State, Federal and Tribal Fishery Agencies Joint Technical Staff

February 26, 2003

We thank you for the opportunity to provide comment on the Independent Scientific Advisory Board's (ISAB) draft document "Review of Flow Augmentation: Update and Clarification" as it relates to the Northwest Power Planning Council's Draft Mainstem Amendments. The document provides several conclusions with which we agree:

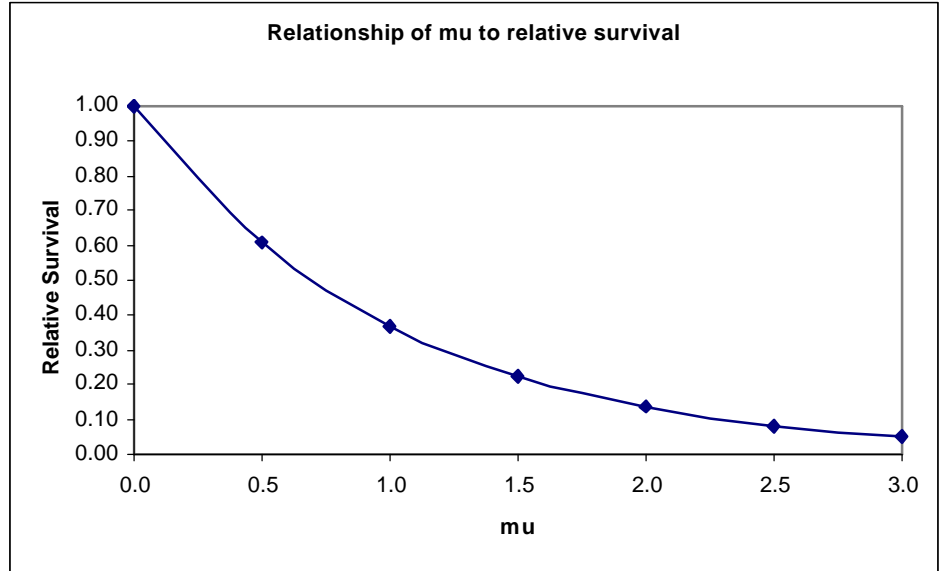
ISAB Question XIV

Figure 28 indicates that relative hydrosystem mortality increased with increased water travel times

Spawner:Spawner vs water travel time & climate/ocean effect (delta)

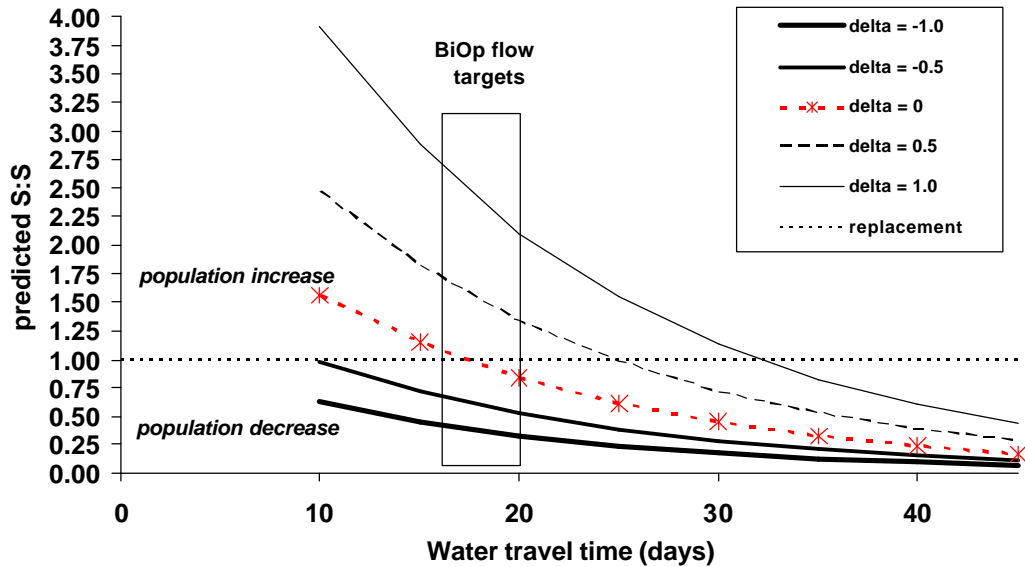
ISAB Question XV part 2

A water velocity and survival (population productivity) relationship is apparent when assessing adult spring/summer chinook information
